**MAINE TURNPIKE AUTHORITY**

**ADDENDUM NO. 2**

**CONTRACT 2019.04**

**INTERCHANGE 103 BARRIER TOLL PLAZA**  
**OPEN ROAD TOLLING CONVERSION**  
**MILE 103.00**

SHEET NUMBER: QN-03  
4 OF 503

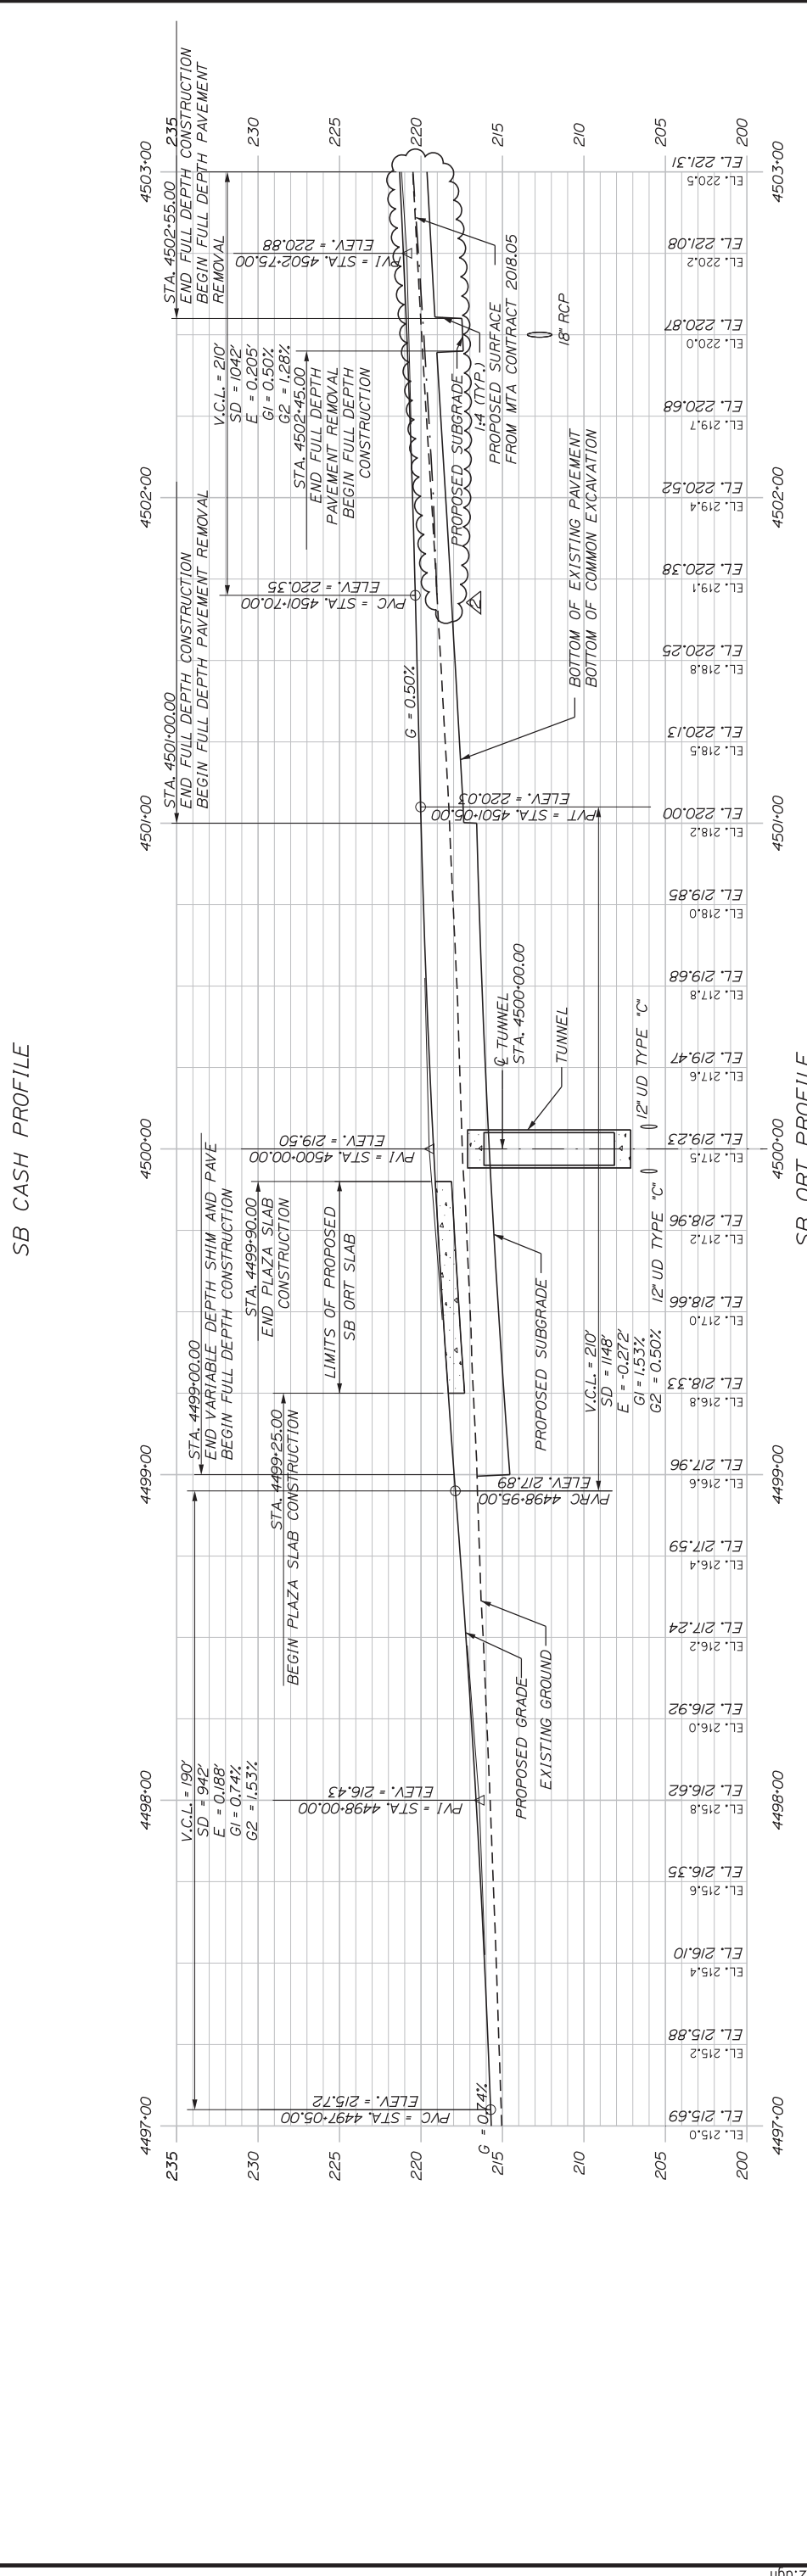
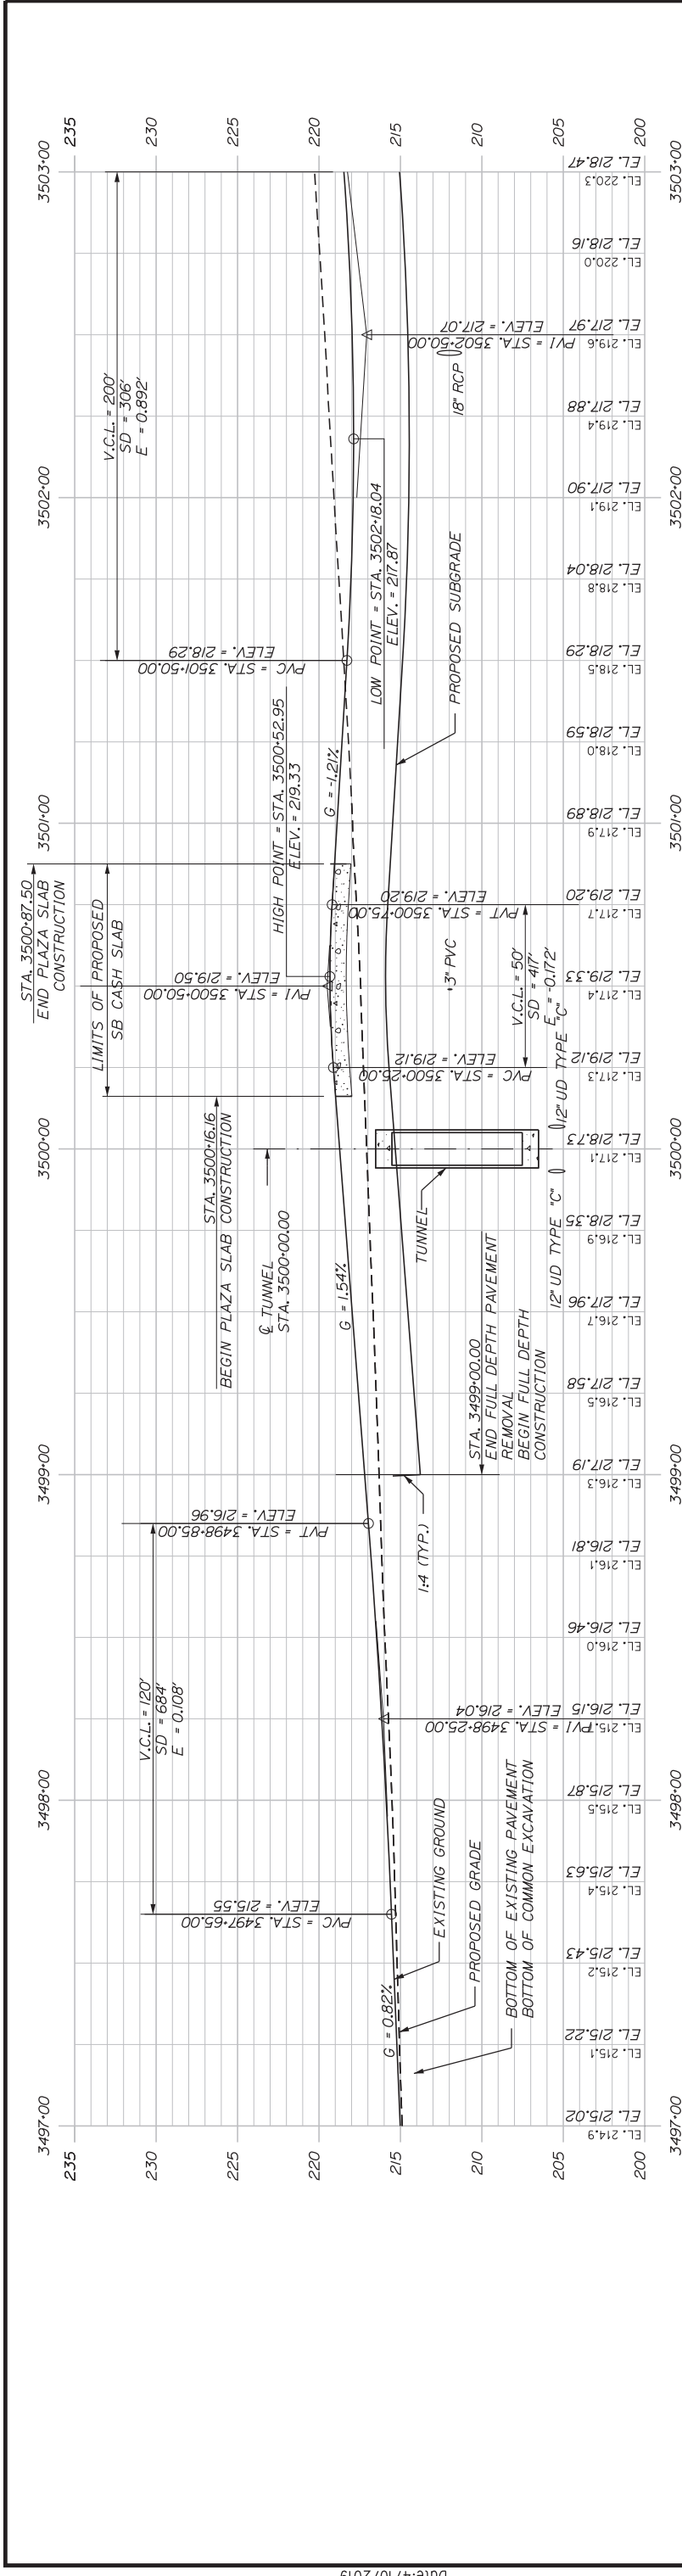
- Plan Sheet 2 of 503, ESTIMATED QUANTITIES – 1, has been deleted in its entirety and replaced with Plan Sheet 2 of 503, included in this addendum.
- Plan Sheet 4 of 503, ESTIMATED QUANTITIES – 3 & EARTHWORKS SUMMARY, has been deleted in its entirety and replaced with Plan Sheet 4 of 503, included in this addendum.

INTERCHANGE 103 ORT CONVERSION  
 SOUTHBOUND PROFILE 4

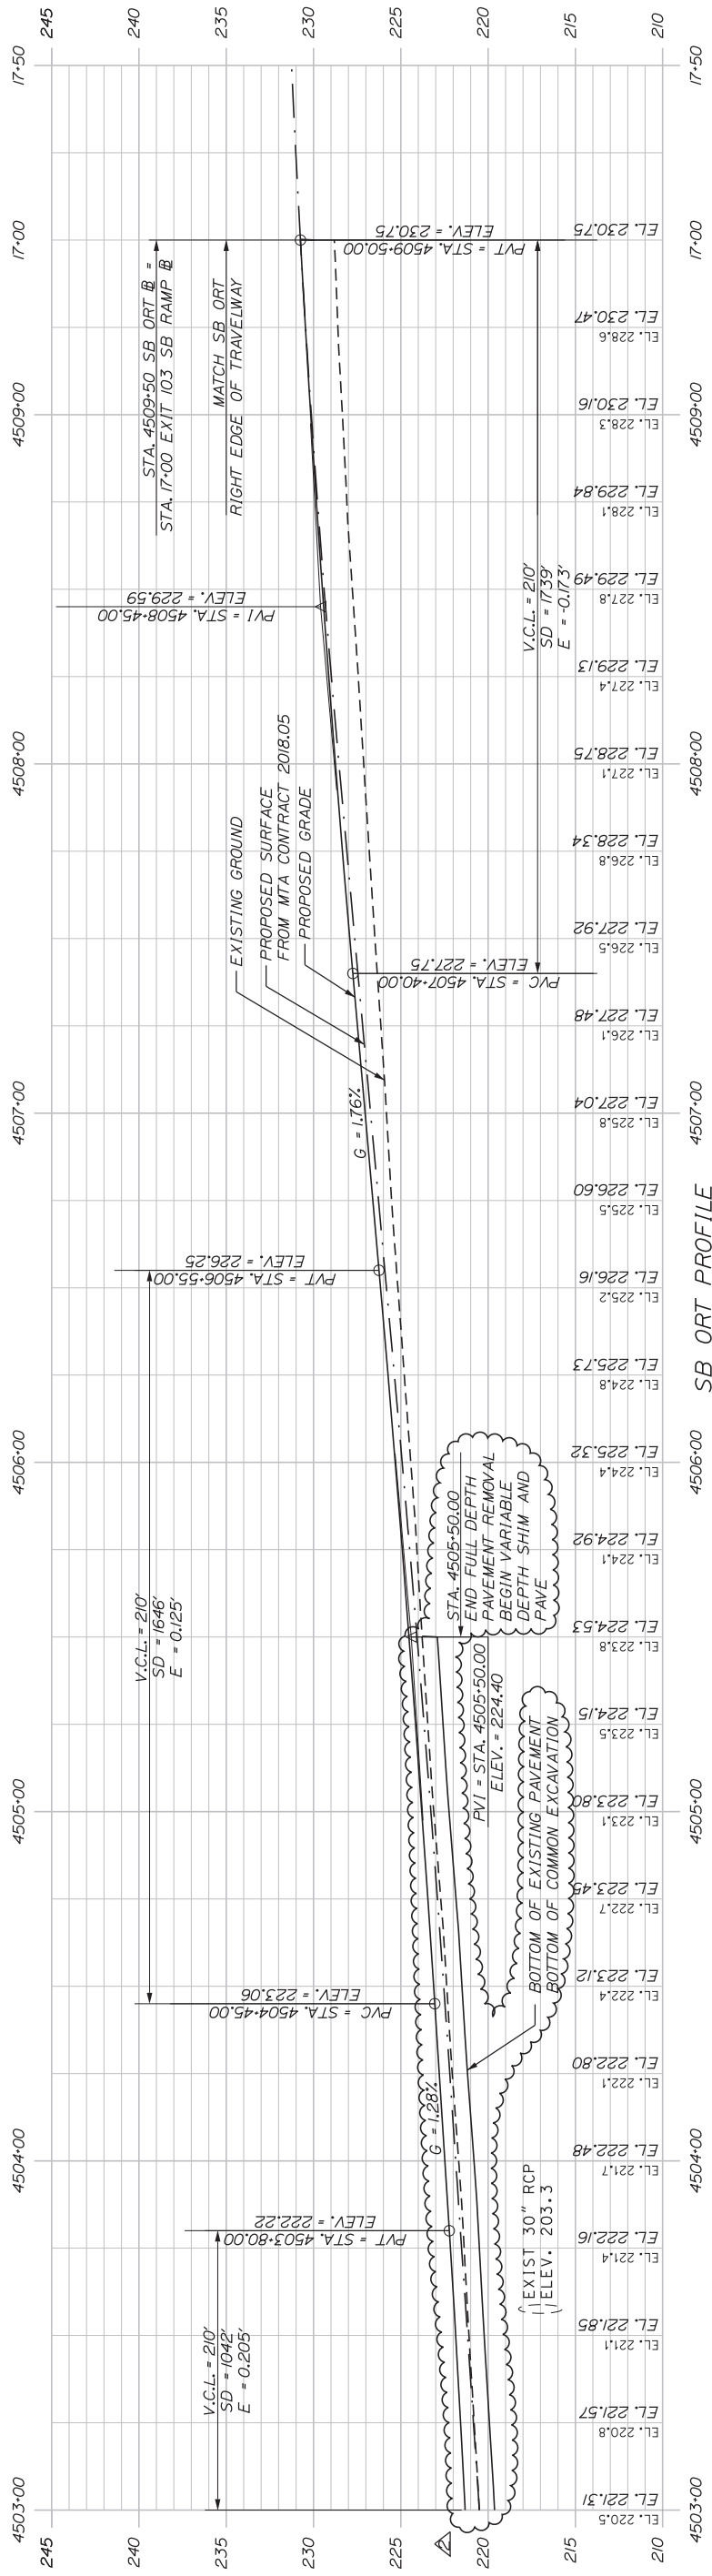
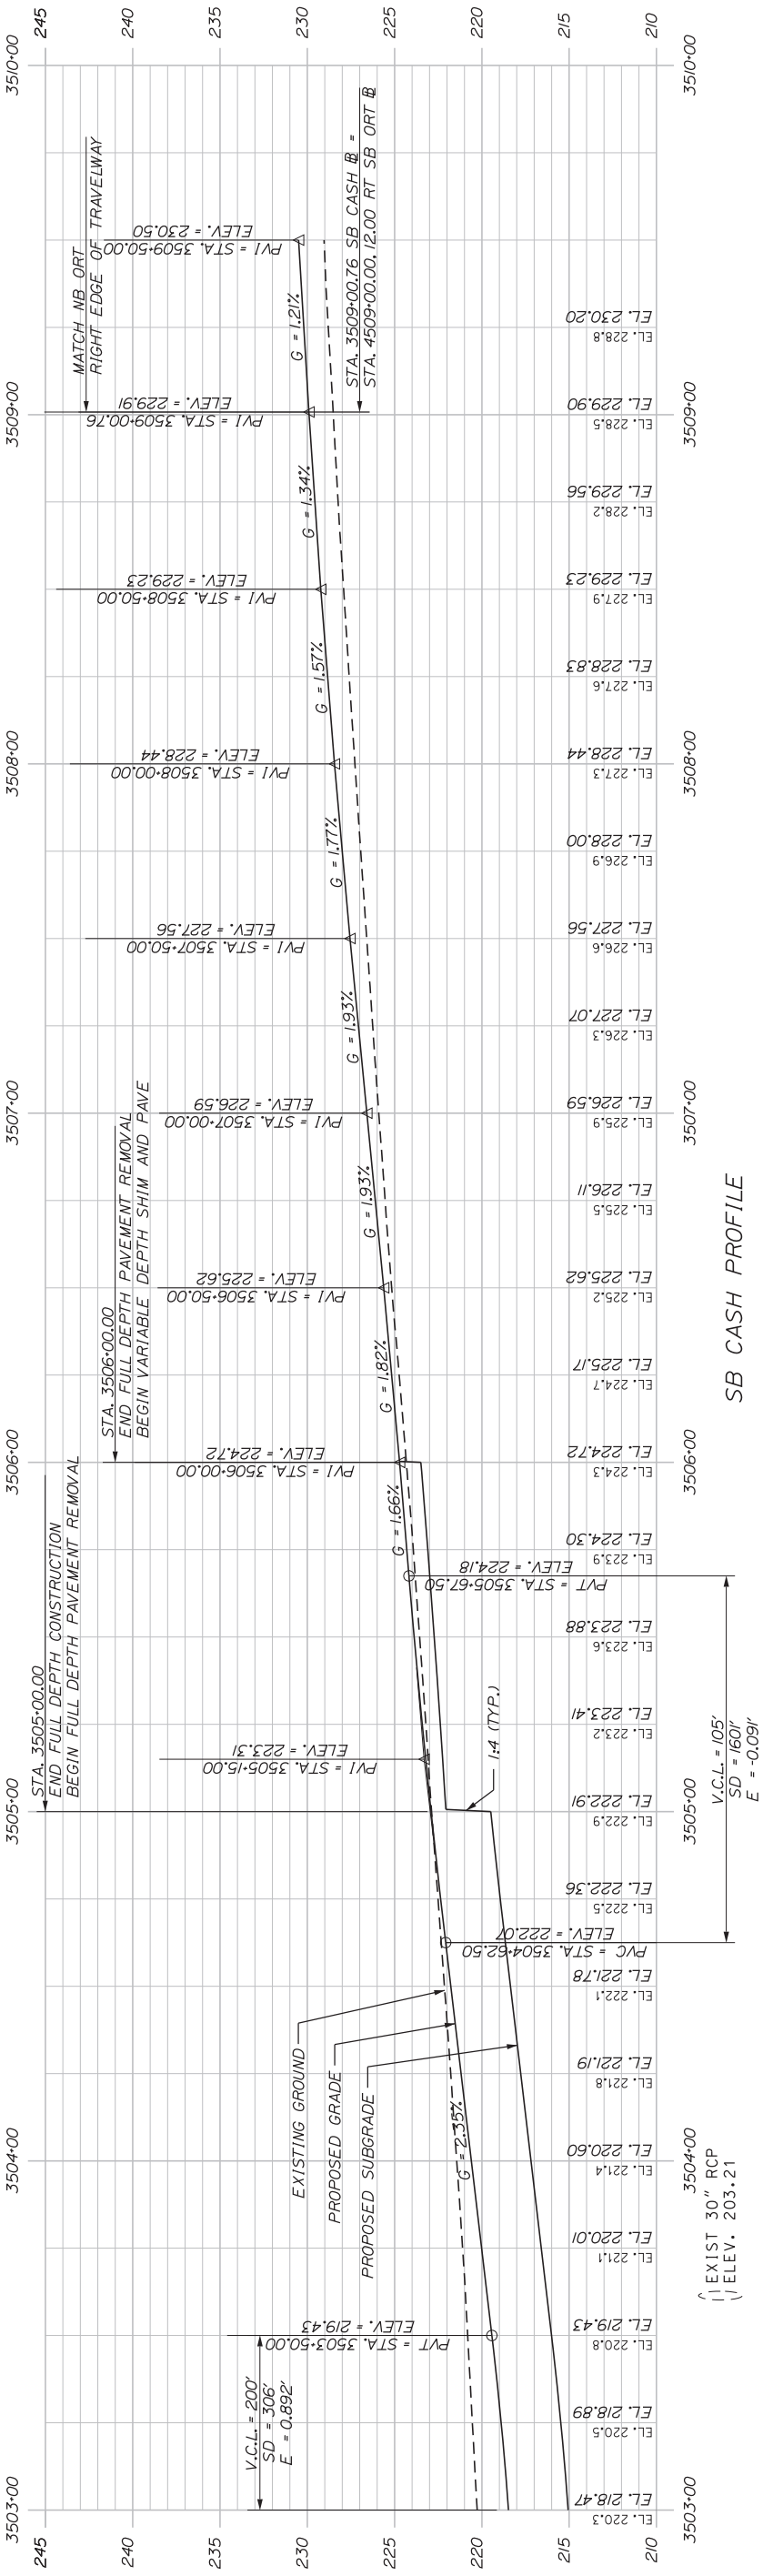
- Plan Sheets 143 and 144 of 503, SOUTHBOUND PROFILE 4 AND 5, have been deleted in their entirety and replaced with Plan Sheets 143 and 144 of 503, included in this addendum.

No.	Revision	By	Date
1	PAVEMENT DEPTH CHANGE	FLP	4/19
